To: Richard Collier, McKim & Creed
From: Brian Chambers, Senior Planner; 910.342.2782
CC: File;
Date: 4/5/2022
Re: Center Point TRC Rev 3

Project Name: Center Point
Response Date: 04/04/2022
Reviewer: Eric Seidel, PE
Department: Engineering – Plan Review Section

PROJECT NAME: CENTER POINT TRC PLAN

CenterPoint Standard Street Lighting Plan

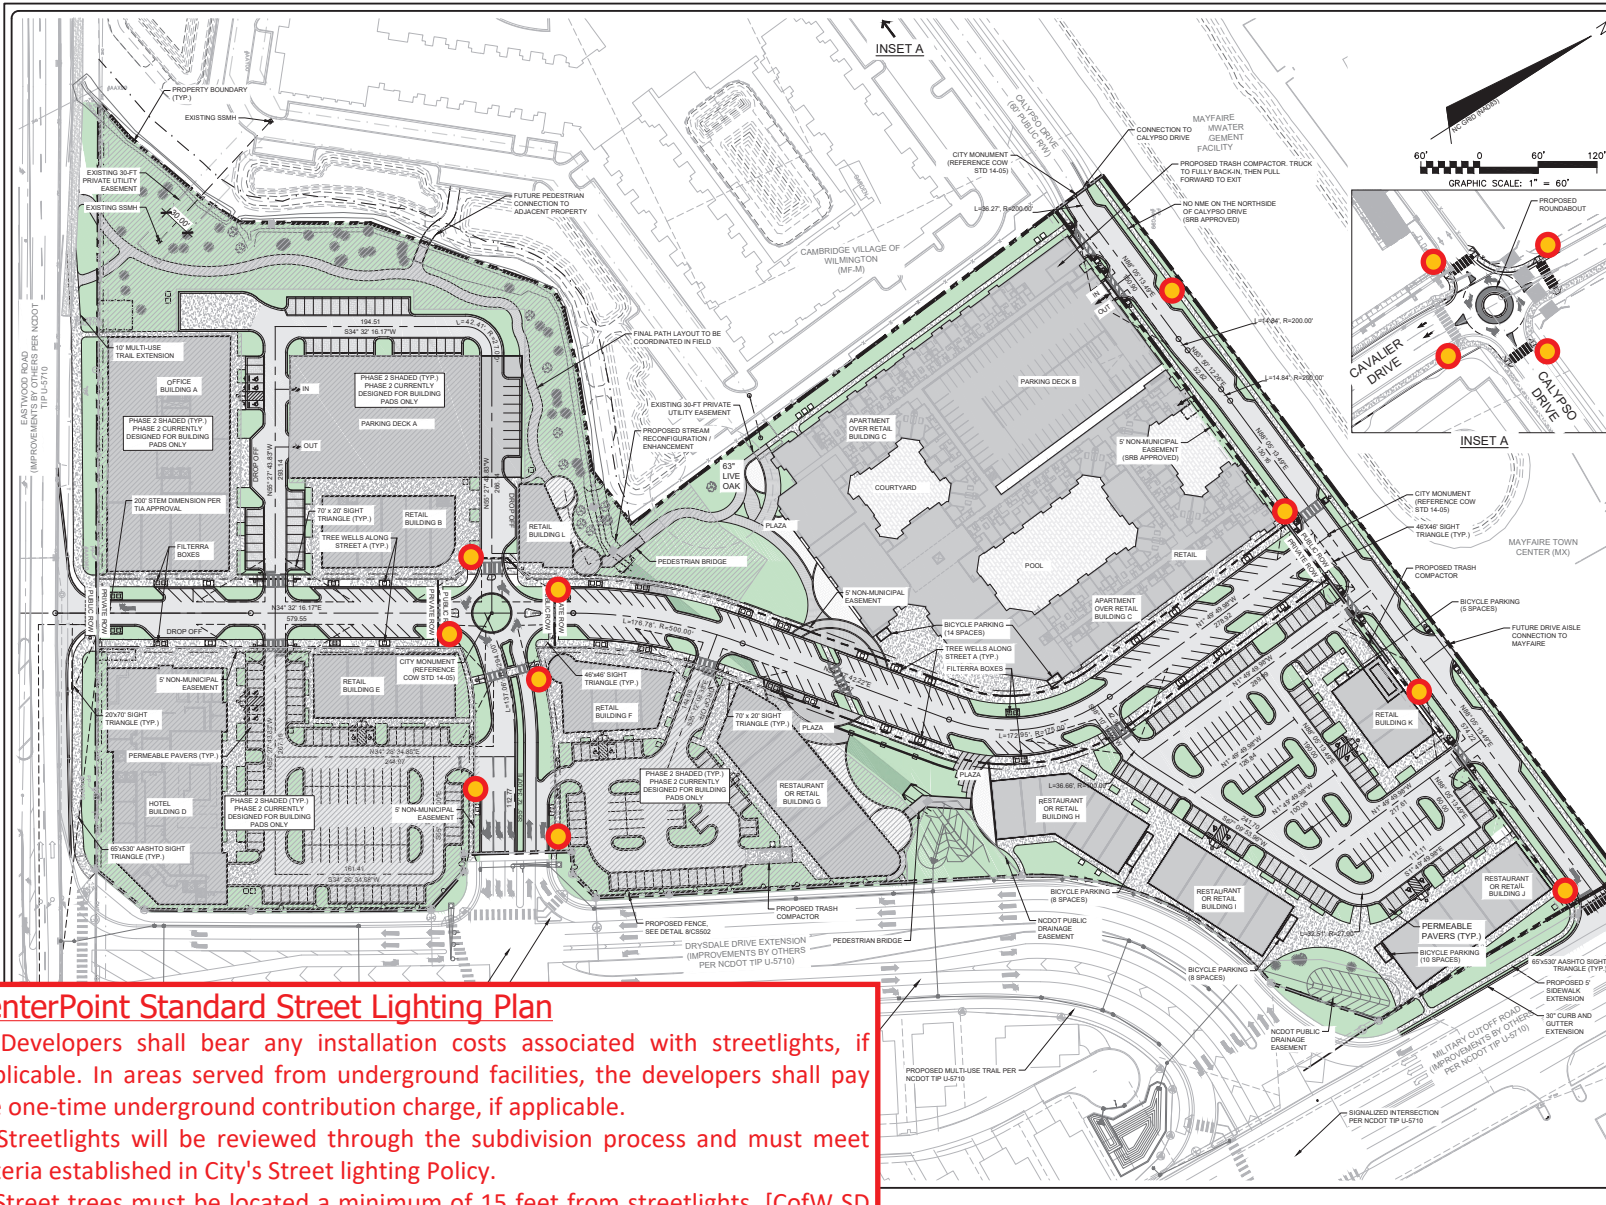
9. A layout for the Standard Street lighting on proposed City maintained public ROWs has been provided with this review. Minimum of 14 (Fourteen) LED50 streetlights are required for this sub-division and roundabout at Calypso Dr/Cavalier Dr. Subject to change based on the study by DEP.

15. Developers shall bear any installation costs associated with streetlights, if applicable. In areas served from underground facilities, the developers shall pay the one-time underground contribution charge, if applicable.
16. Each HOA/PME also shall provide the City a copy of its agreement with DEP for street lighting.
17. If non-standard streetlights are desired, this layout may be used for reimbursement purpose.
18. Street trees must be located a minimum of 15 feet from streetlights. [CofW SD 15-17]
19. All the streetlights shall be installed within the public ROW.
20. Streetlights are required to be installed on ROWs prior to the streets accepted by City for maintenance.
21. Please provide the streetlight plan for the roundabout at Calypso Dr/Cavalier Dr.

● Proposed locations of required 14 LED 50.
Locations may vary as per the field survey by DEP.
